TOWN OF ASHLAND CITY

Planning Commission Meeting

BROOKHOLLOW SENIOR
APARTMENTS
 ASHLAND CITY, TN
 CONSTRUCTION PLANS
 SCALE: 1"=60'

SUBJECT: Brookhollow Senior Apartments
Plan Revision Re-Submittal #1

C3.3

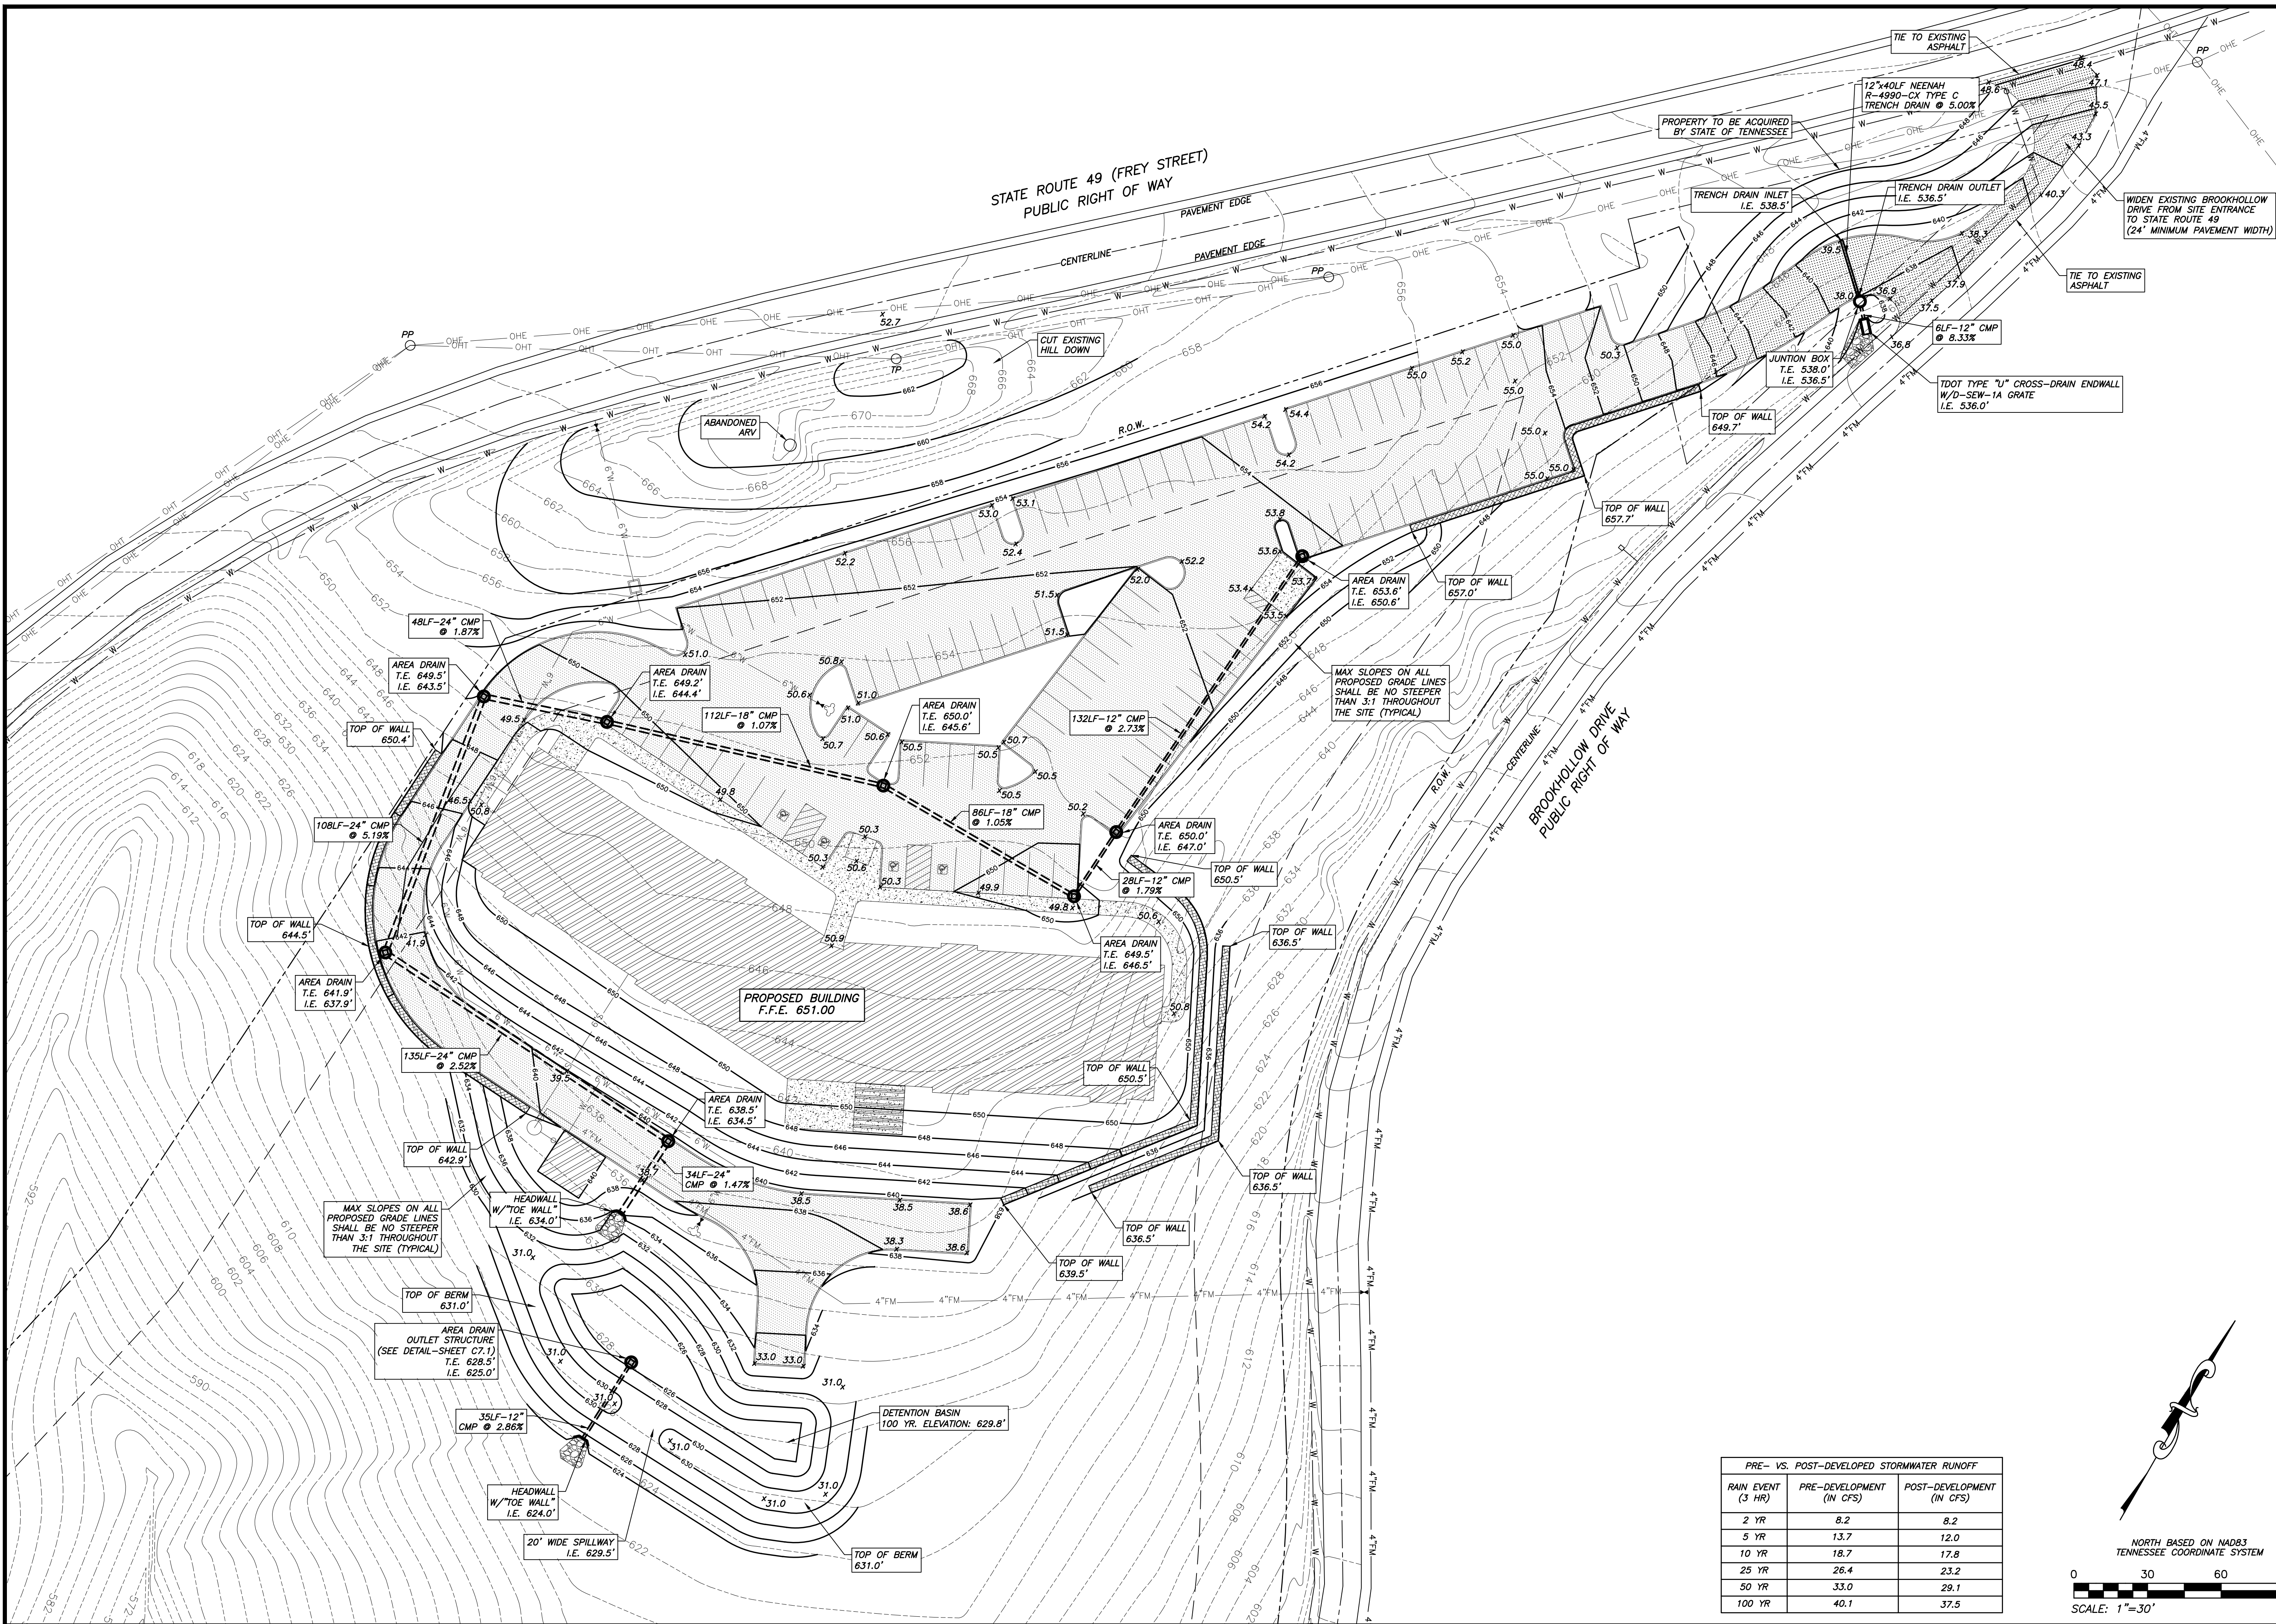
- Sheet C3.3 notes that all disturbed areas shall be seeded and strawed. The relative, permanent seeding mixtures for these areas are noted on sheet C3.0.

C6.0

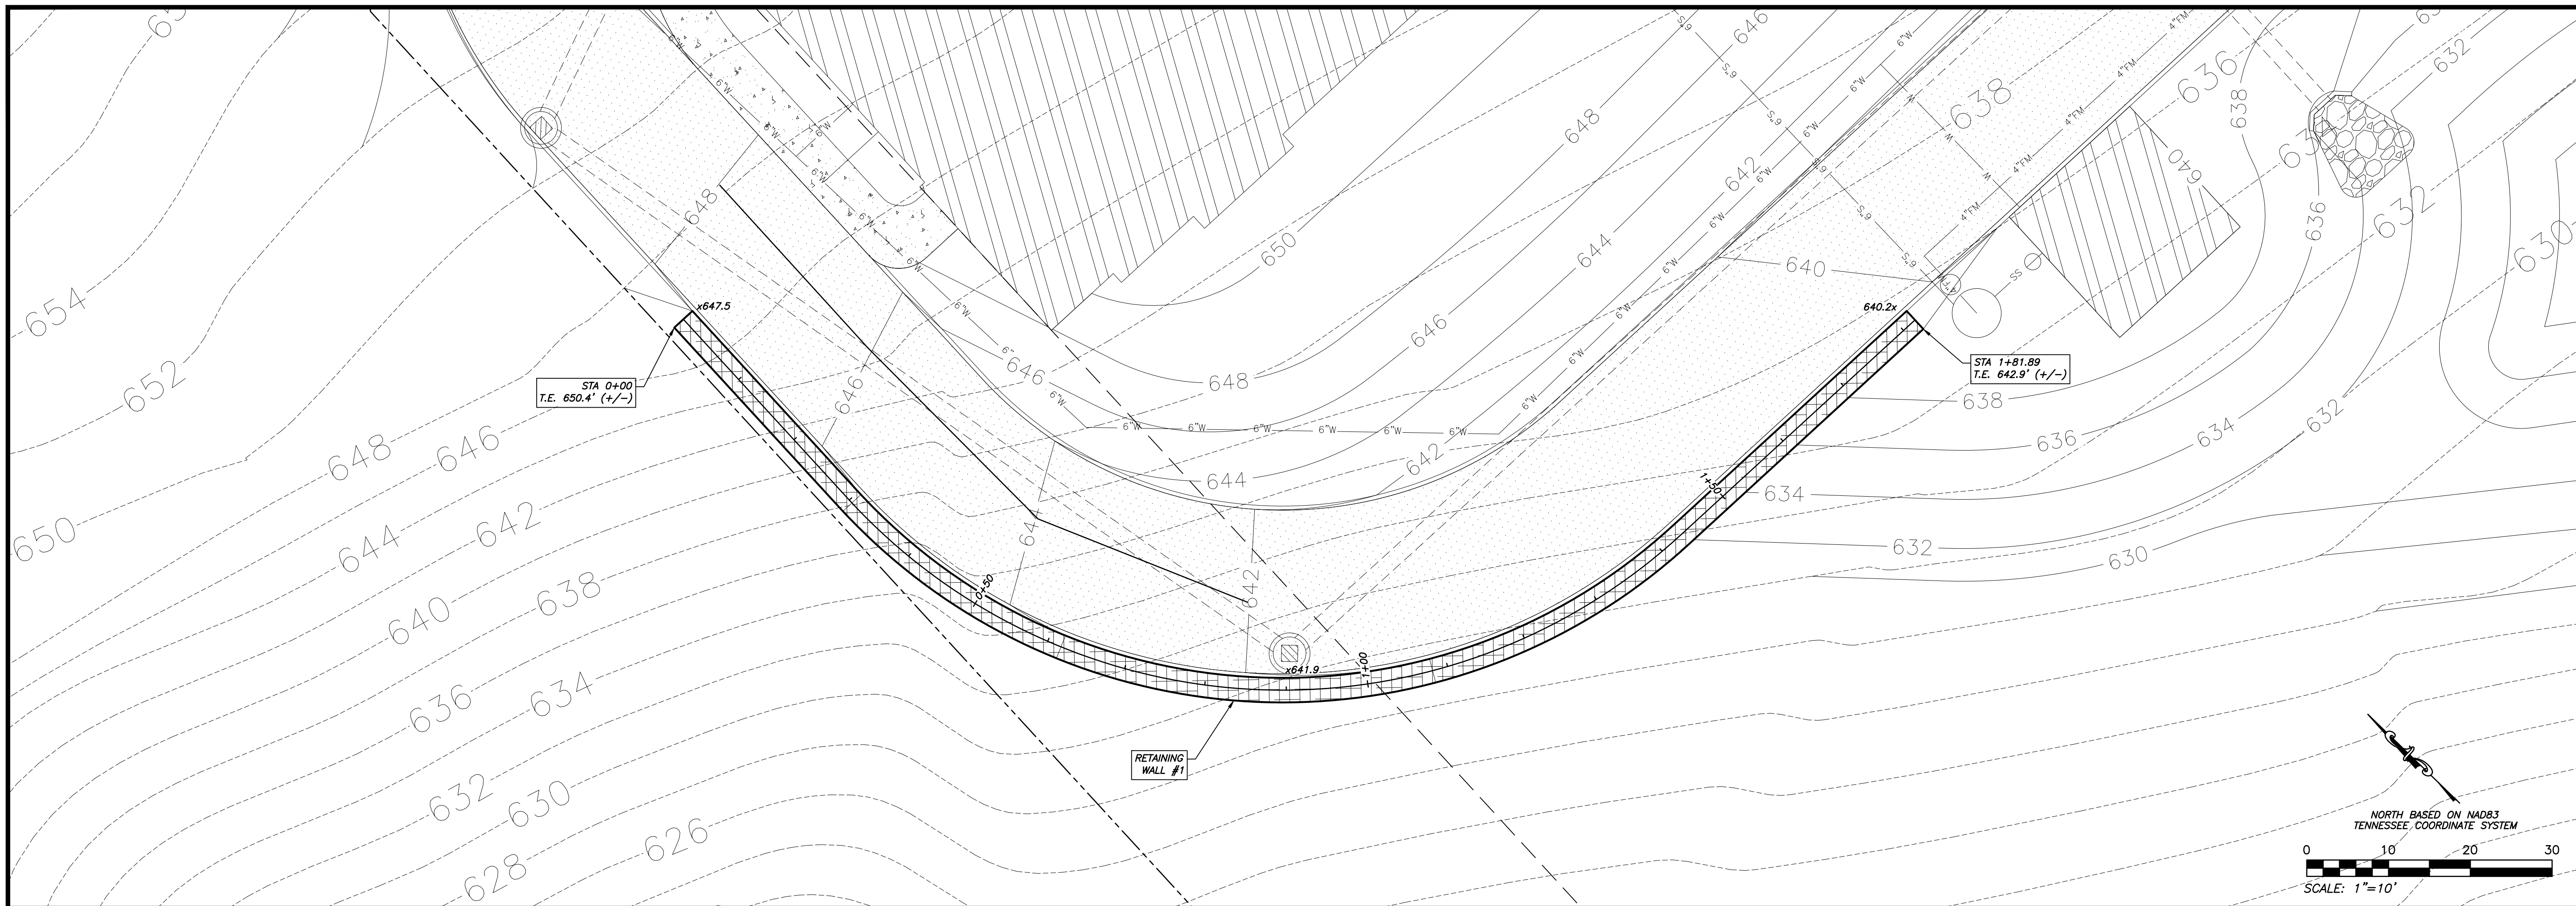
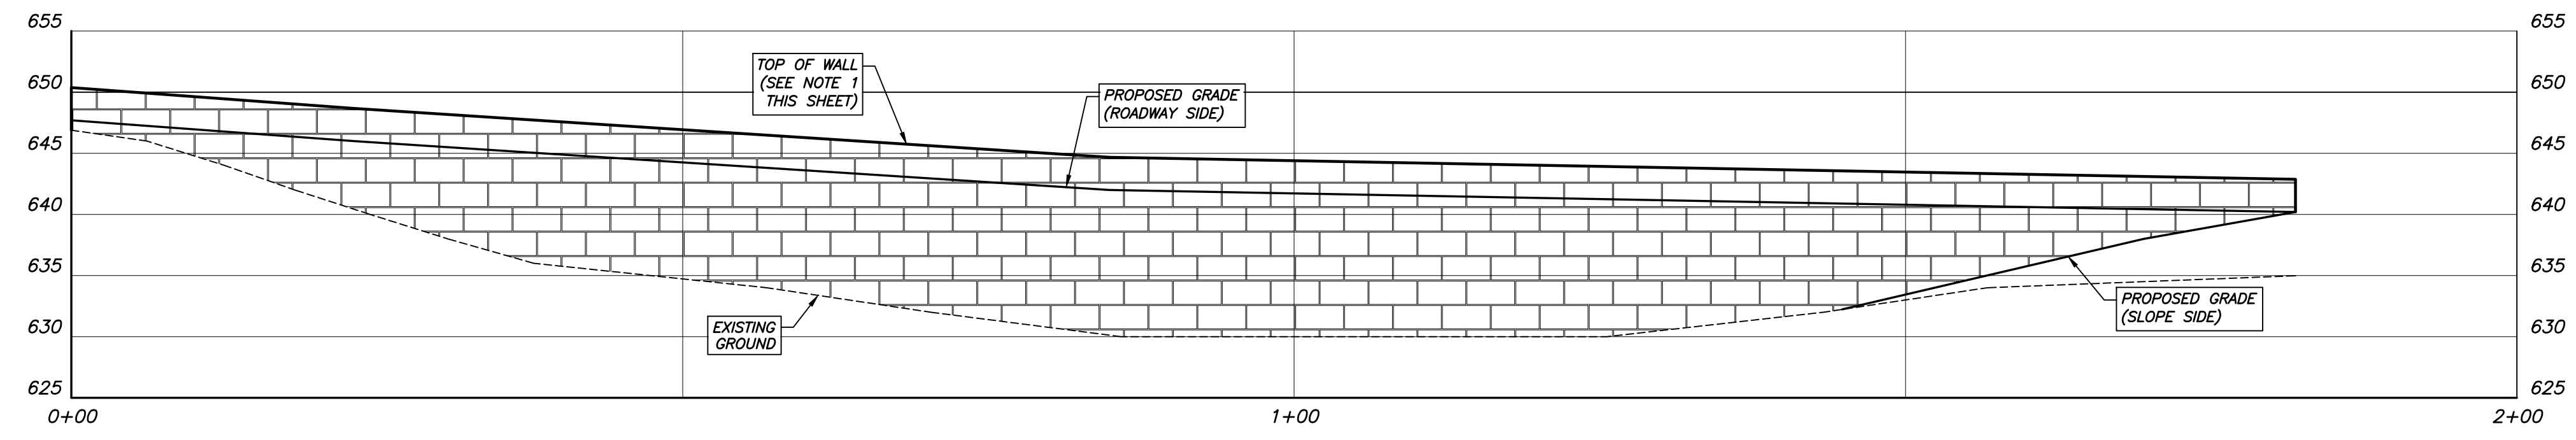
- The developer has retained a structural engineer to design features such as retaining walls, which are outside of our expertise. We would defer to the retaining wall structural drawings for the appropriate interfacing with driveway pavement. We do, however, have an extruded curb detail and pavement section detail on sheet C7.0 of the plans which details the pavement itself. Any variations to interfaces with the pavement through retaining wall sections should be reflected in the structural plans, which have not been provided to us (the civil engineer) at the time of this submittal.

- No proposed grade slopes have been designed to be any steeper than 3:1.
- As mentioned, any further details for wall construction should be part of the structural drawing package.
